MEMORANDUM

SUBJECT: Camelback Planned Unit Development – C814-86-023.01

Camelback PUD

C814-86-023.01

Proposed PUD: Shoreline and Wetlands

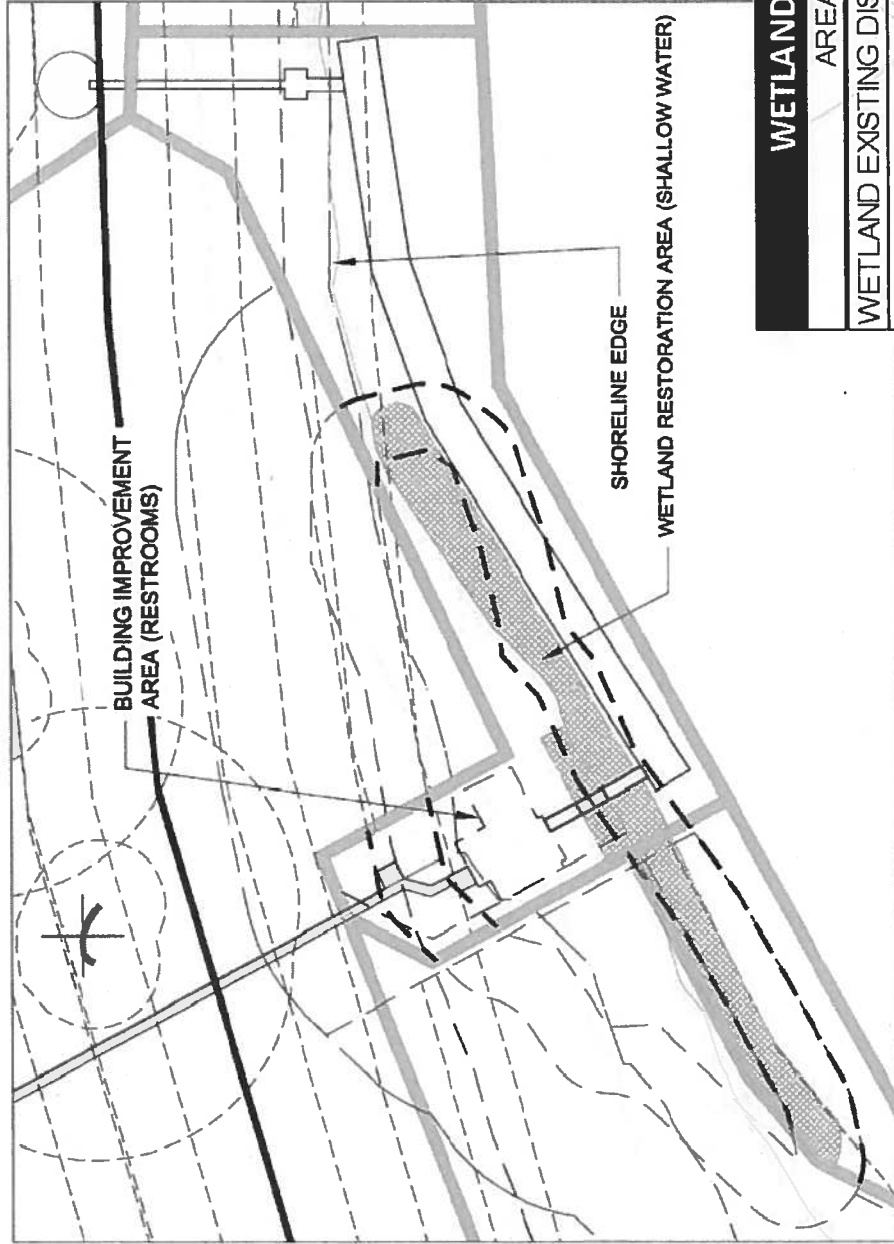
WETLAND RESTORATION

WETLAND CDEF W-6 MITIGATION SUMMARY		
AREA DESCRIPTION		SQUARE FEET
WETLAND EXISTING DISTURBED AREA		57,849.35
WETLAND PROPOSED DISTURBED AREA		13,133.23
WETLAND RESTORATION AREA		23,177.06

- open space and public access restrictions should be further evaluated
- limit boat dock to 14,400 square footage
- evaluate dock distance from shoreline down to 60' and impacts on the wetland

Proposed PUD: Boat Dock and Access

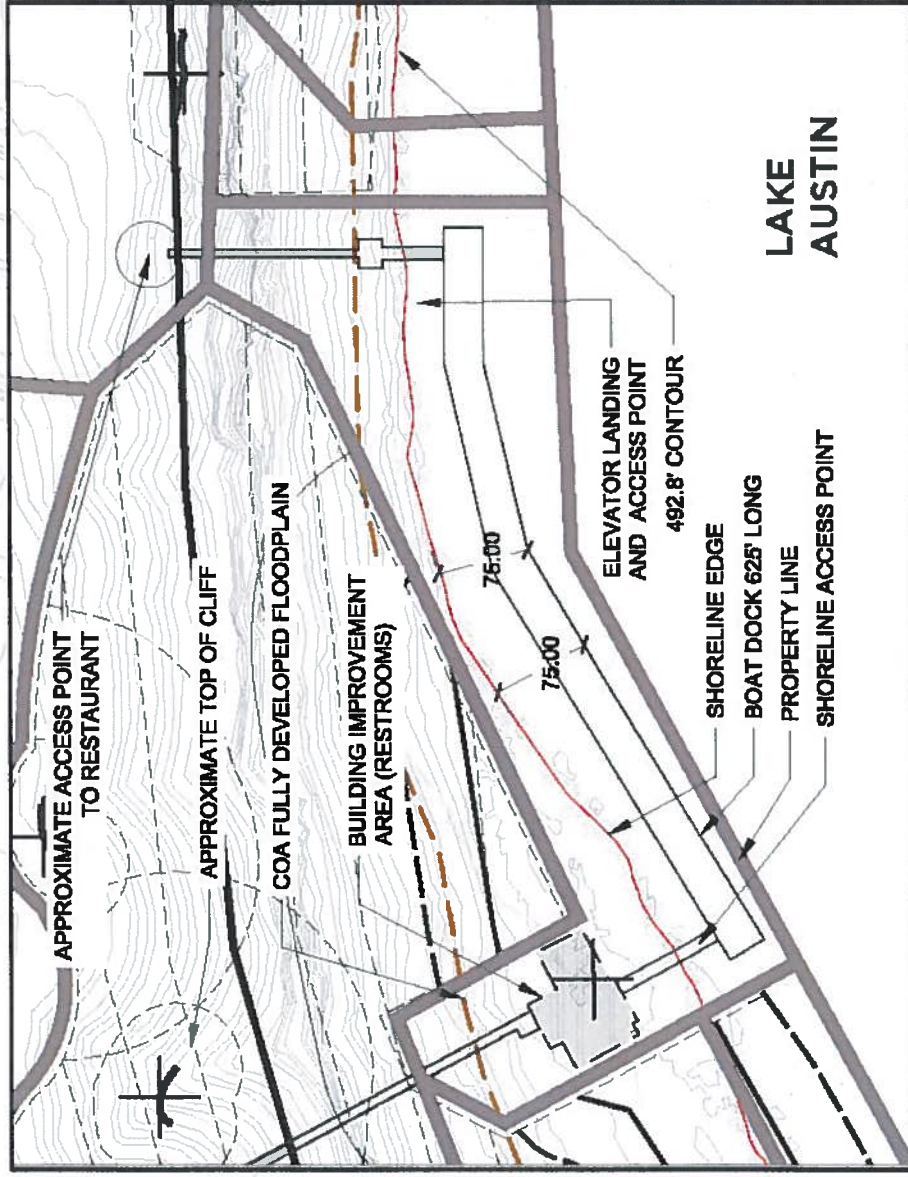
Boat Docks

Existing Code	Existing PUD	Proposed PUD
Cluster boat dock is limited by residential units 600sf/unit	12-2 slip docks Total = 14,400 sf	625 lf dock Total = 18,750 sf

Existing Code	Existing PUD	Proposed PUD
No Mechanized Access	No Mechanized Access	Mechanized access 1. Elevator 2. Tram

- The proposed PUD includes a cluster dock 18,720 ft² in footprint. The Environmental Commission has recommended that the cluster dock be limited to 14,400 ft² in footprint.

- The proposed PUD includes a cluster dock that is 30 ft in length but may extend up to 75 ft from the shoreline. The Environmental Commission recommended an evaluation of reducing the distance of the dock from the shoreline to 60 ft to reduce the potential for navigation safety concerns. Bringing the proposed dock closer to the shoreline would substantially increase the amount of dredging necessary and may reduce the area proposed for wetland restoration. Watershed Protection Department staff prefer limiting the amount of dredging and impacts to the shoreline over bringing the dock closer to the shoreline.

Proposed PUD: Heritage Trees

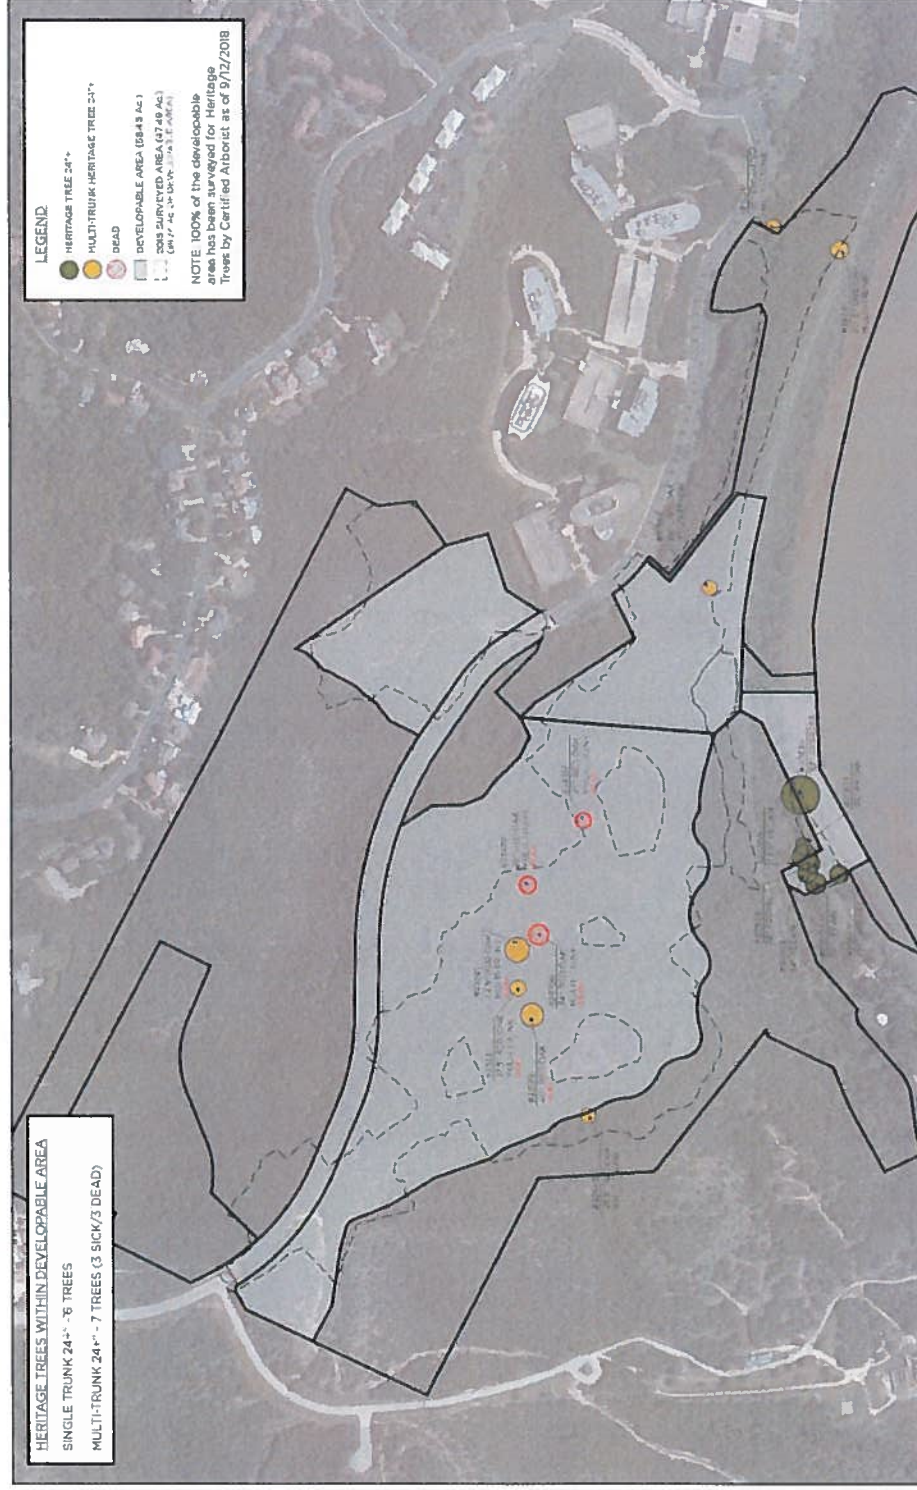
Existing Code	Existing PUD	Proposed PUD
	Protect trees greater than 19"	Current code except administrative removal of heritage trees identified as dead or diseased. Specifically Trees #: 23179, 23231, 23381*, 23399, 23472*, 24317*

*Tree health to be verified before PUD goes to Planning Commission

- verify the trees listed are dead or dying per the applicant's arborist report
- work with staff to establish a minimum buffer for the bluff
- tram/elevator/inclinor issues need to be finalized with safety and environmental constraints as applicable
